Our Ref: BE250306 20260528-Response to RFI  
Enquiries to: Jack Shao

**Re: Proposed Reconfiguring a Lot (2 Lots into 199 Lots and 2 Balance Lots)  
Meringandan Road, Meringandan  
Lot 3 AG4138 & Lot 1 RP27298  
Information Request Response  
Council Reference: RAL/2025/5992**

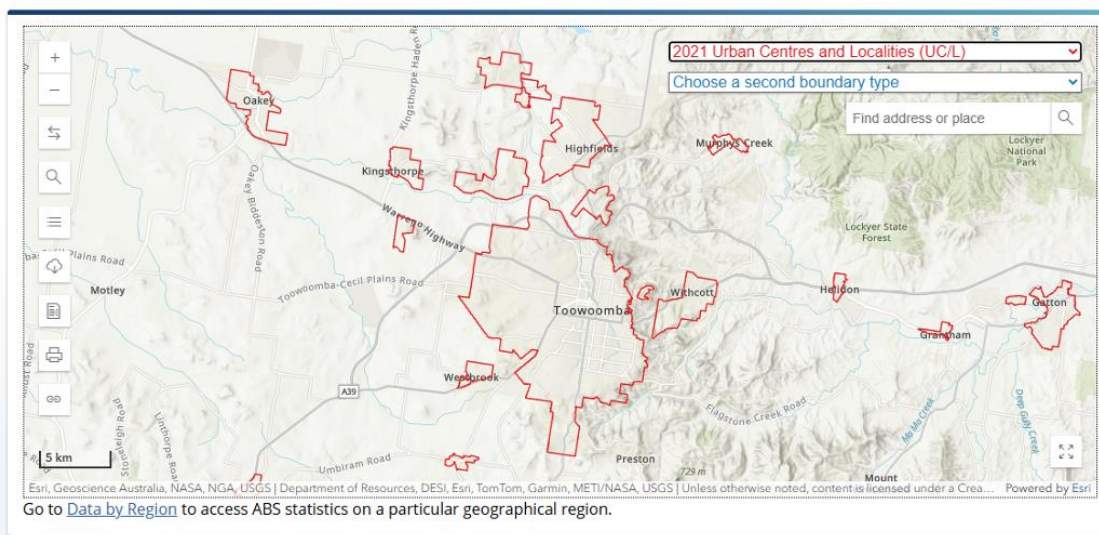
(c) Council has concerns regarding the assumed fraction impervious values given approximately 45% of lots are proposed to be 400m<sup>2</sup> or less. A fraction impervious of at least 80% should be used for residential lots; and

(b) A fraction impervious of at least 80% should be used for residential lots;

c). The hydrologic modelling has been updated to adopt a minimum fraction impervious of 80% (or equivalent IL and CL applied in the hydraulic modelling) for residential lots.

This revised impervious assumption reflects the proposed residential lot sizes, including the proportion of lots that are 400 m<sup>2</sup> or less.

The updated impervious fractions have been used in the revised hydrologic modelling and inform the updated peak discharge assessment, detention basin sizing and hydraulic impact assessment.

## ABS Maps

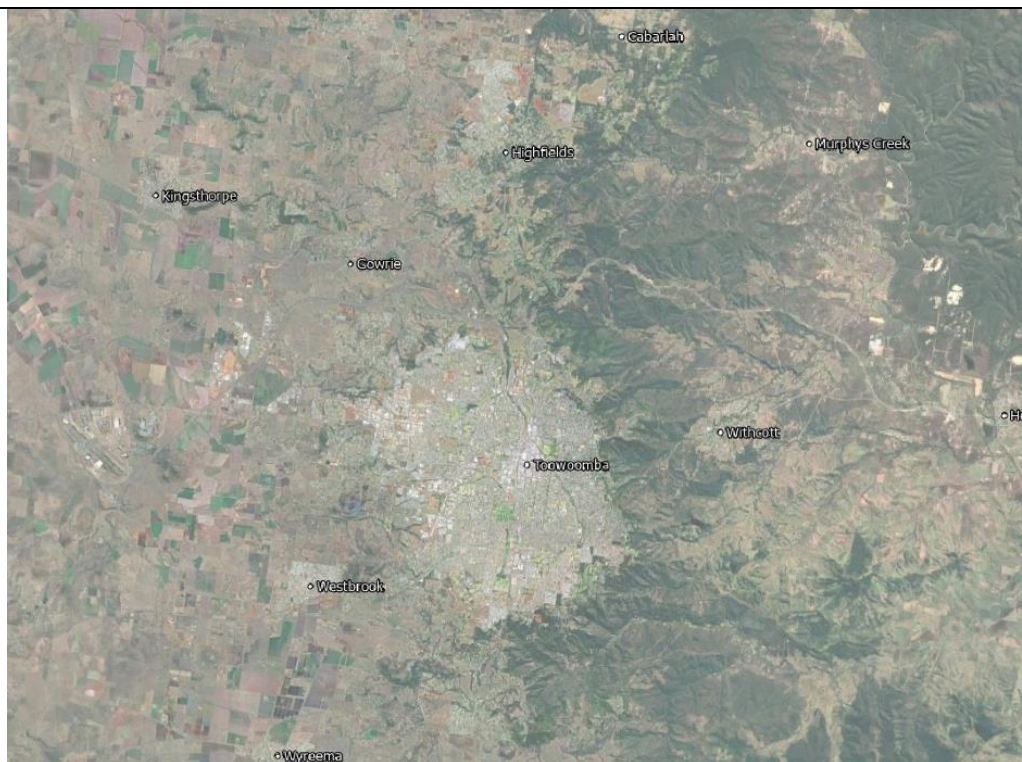
(d) There is no stormwater quality treatment proposed. As outlined within the pre-lodgement advice, stormwater quality treatment must be provided that meets the post-construction design objectives for water quality within the State Planning Policy July 2017. Stormwater treatment facilities must be located in drainage reserves or streets with provision made for maintenance access. Treatment facilities could include street tree bio-retention pods, grass swales, and bio-retention filters.

(d) Stormwater quality treatment that meets the design objectives of the State Planning Policy.

The State Planning Policy 2017, Planning Act 2016 and Planning Regulation 2017 do not specifically define the term “population centre” for the purpose of applying the stormwater quality design objectives. In the absence of a specific statutory definition, the accepted approach is to interpret population centres by reference to the Australian Bureau of Statistics Urban Centres and Localities classification and associated Queensland Government population centre mapping. This has been confirmed by various government departments <https://data.gov.au/data/dataset/population-centres-queensland>

On this basis, Meringandan is identified as a separate population centre and is not part of the Toowoomba urban centre. Meringandan has a population of less than 25,000 people and is located within the Western Queensland climatic region.

Accordingly, while the State Planning Policy stormwater quality provisions have been considered, the post-construction pollutant reduction targets for Western Queensland population centres greater than 25,000 people are not applicable to the development. Permanent stormwater quality treatment infrastructure is therefore not required to achieve SPP pollutant load reduction targets.
